Potential Leak Issues With 90 PSIG Nitrogen

(From a letter dated March 5, 2001 in response to a leaking nitrogen line)

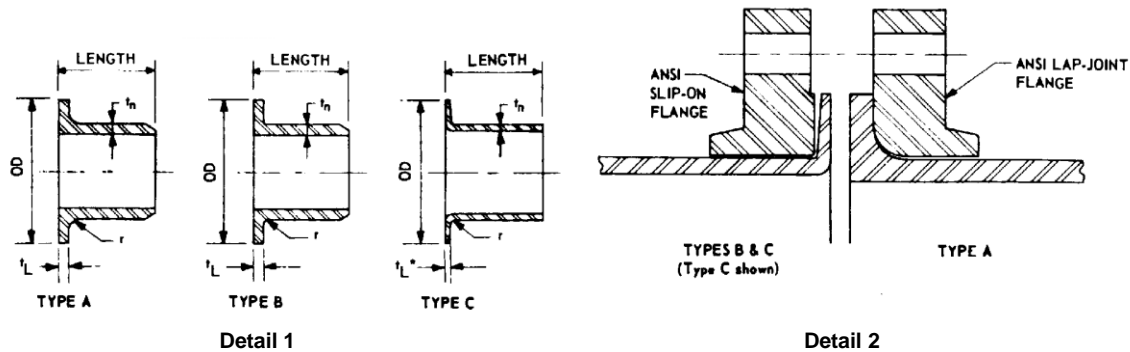
You can see by Detail 1 the different types of stub-ends that are available. Types A & B are manufactured and type C is flared pipe or tubing. The type C stub-end can either be purchased or it can be tubing flared by the fabricator.

Looking at Detail 2 you can see how the Type A stub-end (also referred to as a Lap-Joint stub-end) has an outside knuckle radius that conforms to the radius of the lap-joint flange. Types B & C are squared off to conform more to a slip-on flange. The thickness of the flared portion of the types A & B stub-ends can be no less than the thickness of the pipe or tubing. However, the type C stub-end can be 75% the thickness of the pipe or tubing making it more susceptible to damage due to poor handling. In addition, the type C stub-end does not have serration's on the facing of the flare to provide sealing influence.
